Q-336R1

SVE BULLETIN

QVM BULLETIN: Q-336R1 DATE: 7 / JULY / 2021

2021MYF59 COLUMN MOUNTED SHIFTER

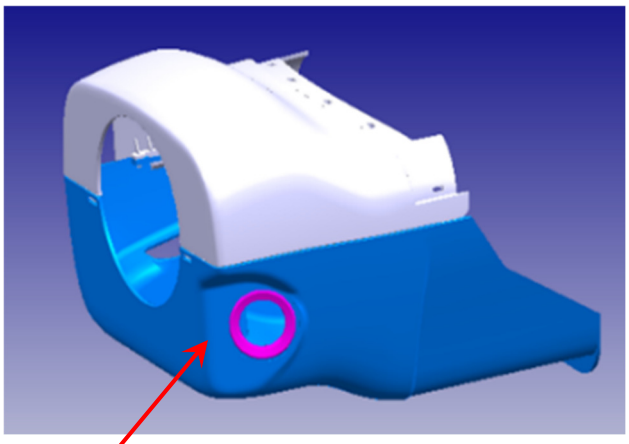
If Dash-Mounted Shifter and Dash Mounted Ignition Switch are **NOT** required for the vehicle vocational upfit, then W718409-S300 Plug must be installed.

Remove the ring/Bezel from the shroud and install plug W718409-S300

W718409-S300 Plug

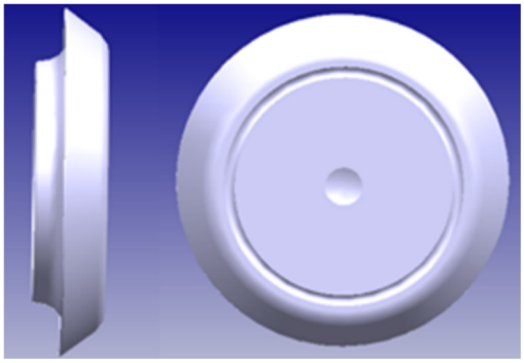
If Dash-Mounted Shifter and the Ignition Switch are to be retained in the factory position, then the W718409-S300 plug is not needed.
